AECOM SILT TRENCH REVIEW

Project name:
Seven Hills Windfarm

Project ref:
60634578_ACM_MO_CE_001_0

Subject: Slit Trench Review

Silt Trench 1

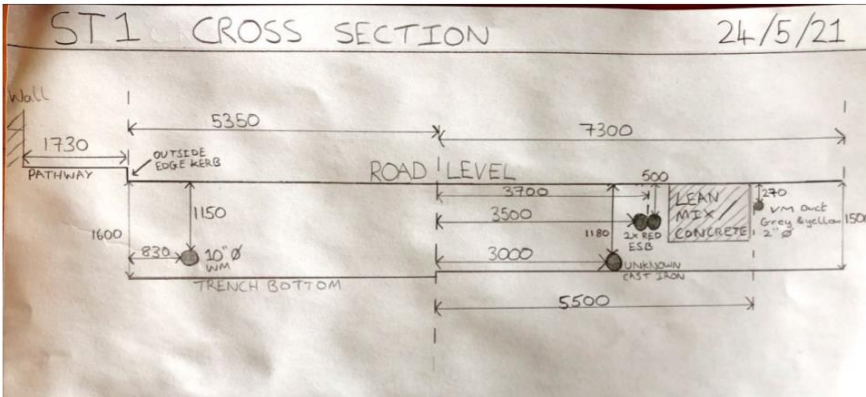
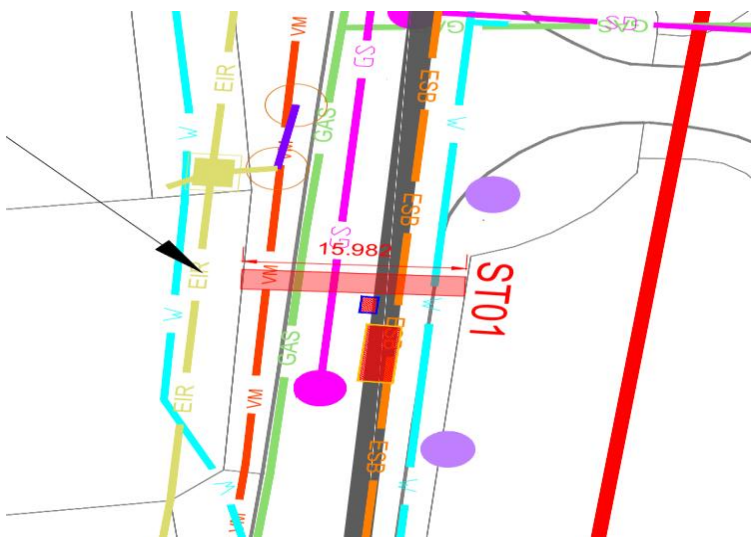
Utility	On Drawing	In Silt Trench	Comments
Irish Water	Yes	Yes	250mm dia. WM.
EIR	Yes		
Virgin Media	Yes	Yes	
GAS	Yes	-	
Gravity Sewer	Yes	-	Assumed below depth of trench dig.
ESB	Yes	Yes	2-way duct
Water	Yes	-	None
Public Lighting	-		In footway
Other	-	Yes	Cast iron - unknown – invert nmt 1.8m. Lean mix concrete - Could be cover.
Summary	Inverts of identified services as expected. Silt trench appears to have less services than dwgs. Impact on cable route minimal. Location of cable should not impinge conc. cover Open trench would be feasible through this section based on ST (silt trench) info. (see Detail A - see Dwg 60634578-ACM-DR-CE-036- Appendix 1).

Silt Trench 3

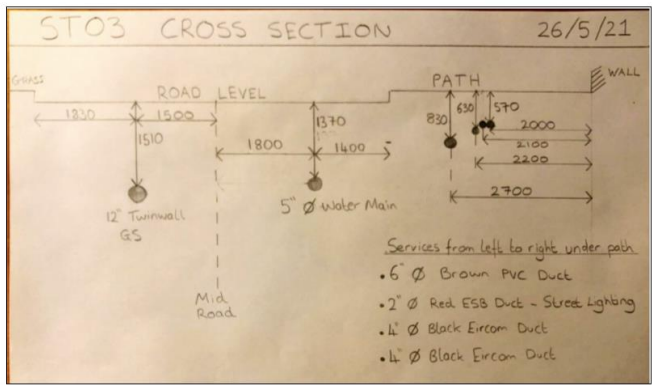
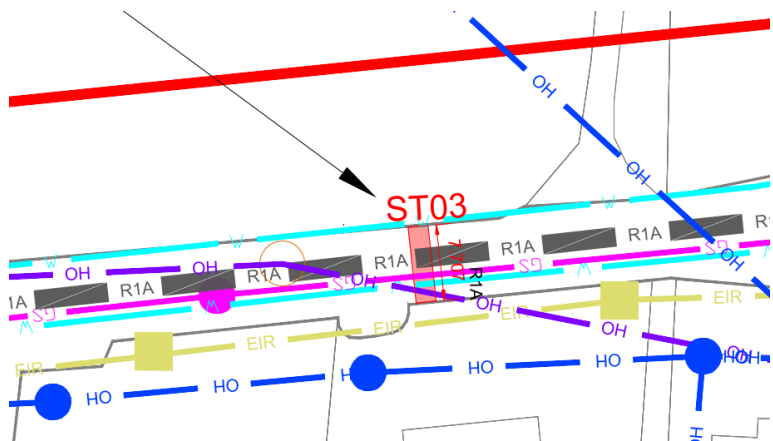
Utility	On Drawing	In Silt Trench	Comments
Irish Water	Yes	Yes	125mm dia. WM.
EIR	Yes	Yes	Footway 2-way duct
Virgin Media	-	-	
GAS	-	-	
Gravity Sewer	Yes	Yes	300mm diameter with 1.51m cover. (This more like Storm if twin wall)>>
ESB	-	-	
Irish Water	Yes	-	None
Public Lighting	-	Yes	In footway
Other	-	Yes	Footway Brown (150mm dia.) - This is Sewer or road storm.
Summary	Inverts of identified services as expected. Silt trench appears to have less services than dwgs. Impact of cable route minimal. Open trench would be feasible through this section based on ST info. (see Appendix 2 - Detail A or B - see Dwg 60634578-ACM-DR-CE-036).

Silt Trench 4

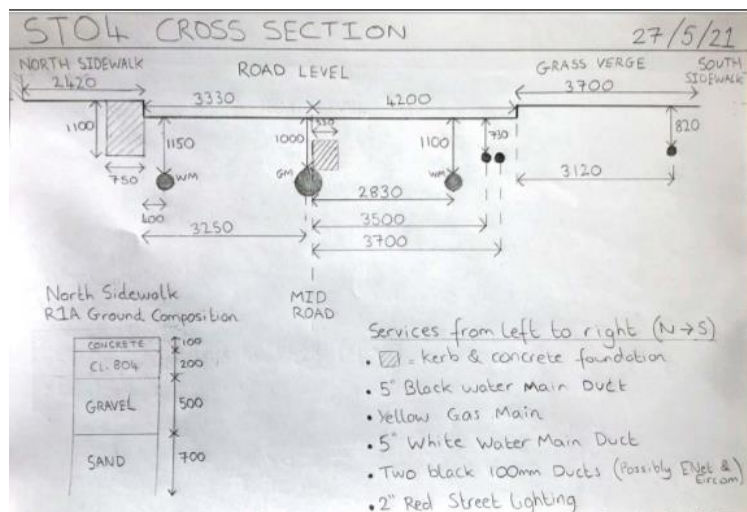
Utility	On Drawing	In Silt Trench	Comments
Irish Water	Yes	Yes	125mm dia. WM.
EIR /ENET	Yes	Yes	2-way duct or ENET??
Virgin Media	Yes	-	
GAS	Yes	-	
Gravity Sewer	Yes	Yes	300mm diameter with 1.51m cover. (This more like Storm if twin wall)>>
ESB	-	-	
Irish Water	Yes	-	None
Public Lighting	-	Yes	In verge -2 way
Other	-		
Summary	Inverts of identified services as expected. Silt trench appears to have less services than dwgs. Impact on cable route minimal. Open trench would be feasible through this section based on ST info. (see Appendix 2 - Detail A or B - Dwg 60634578-ACM-DR-CE-036).

Silt Trench 5

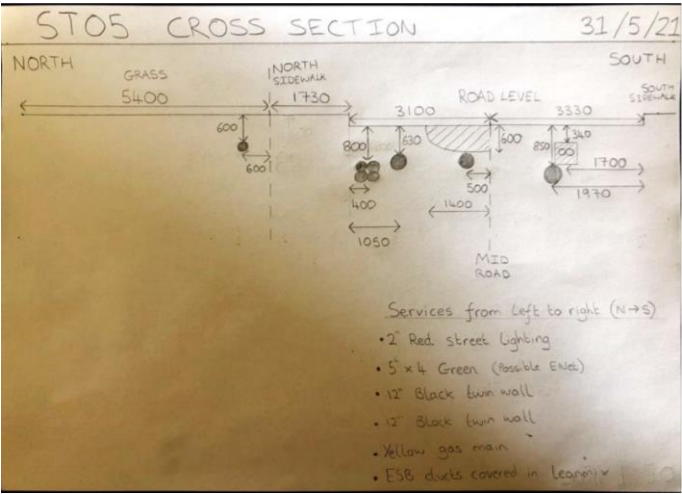
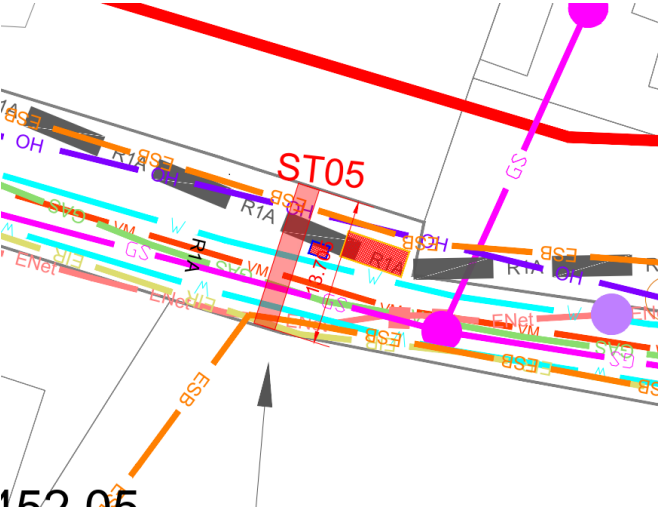
Utility	On Drawing	In Silt Trench	Comments
Irish Water	Yes	Yes	125mm dia. WM.
EIR /ENET	Yes	Yes	4 way + 2-way duct or ENET??
Virgin Media	Yes	-	Maybe in 4 way or 2 way?
GAS	Yes	Yes	No size stated – yellow duct (See Appendix 1)
Gravity Sewer	Yes	Yes	2 nr 300mm dia. 600mm average cover. (This more like Storm if twin wall)>>
ESB	Yes	-	2 way
Irish Water	Yes	-	None
Public Lighting	-	Yes	
Other	-		
Summary	Inverts of identified services as expected. Twin wall inverts high (may need diverted – clarify if storm or foul). Silt trench appears to have less services than dwgs. Impact on cable route based on ST info would be for

cable route to run under telecom ducting – northern side. (see Appendix 2- Detail A - see Dwg - 60634578-ACM-DR-CE-036).
--

Silt Trench 6

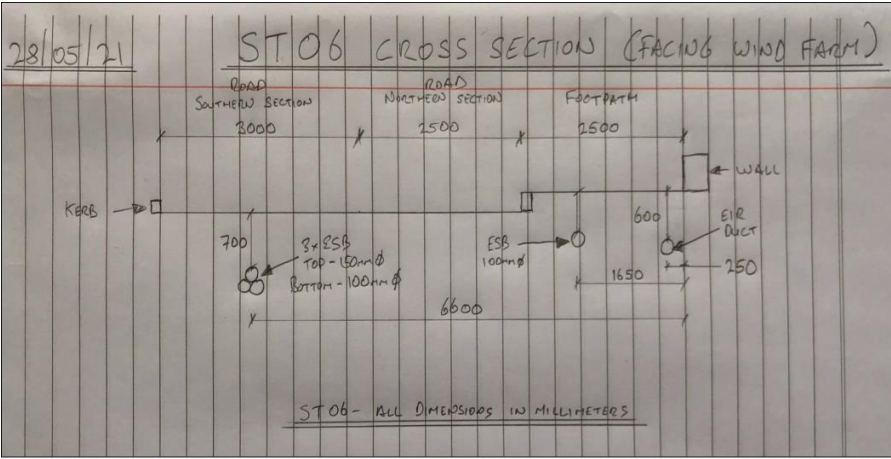
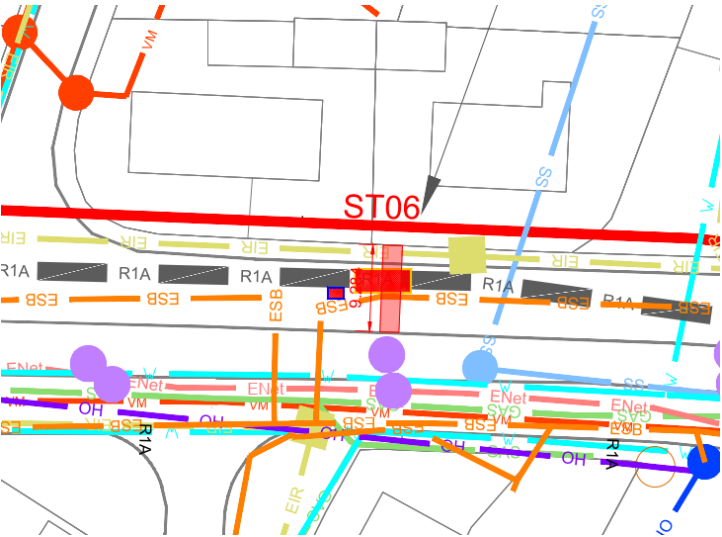
Utility	On Drawing	In Silt Trench	Comments
Irish Water			
EIR /ENET	Yes	Yes	1 -way duct
Virgin Media		-	
GAS		-	
Gravity Sewer		-	
ESB	Yes	Yes	3-way trefoil and 1 way
Irish Water		-	
Public Lighting	-	-	
Other	-

Silt Trench 10

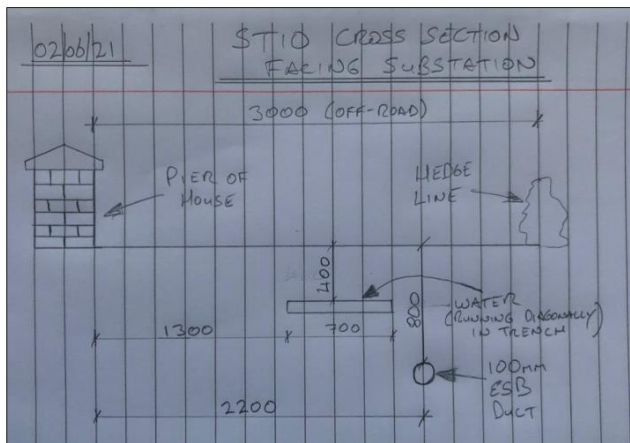
Utility	Drawing	Silt Trench	Comments
Irish Water			None
EIR/ENET		Yes	3-way duct + 1 -way duct ENET
Virgin Media		-	
GAS		Yes?	Potential gas stated under CBGM which had power cable running through it.
Gravity Sewer			
ESB		Yes	2-way power duct (ESB)
Water			None
Public Lighting		-	
Other			
Summary	Silt trench has ESB service only. Water running may need directed and made good. Based on ST findings this will have minimum impact on the planned cable route. See Appendix 2 - Details proposals -Dwg 60634578-ACM-DR-CE-036).
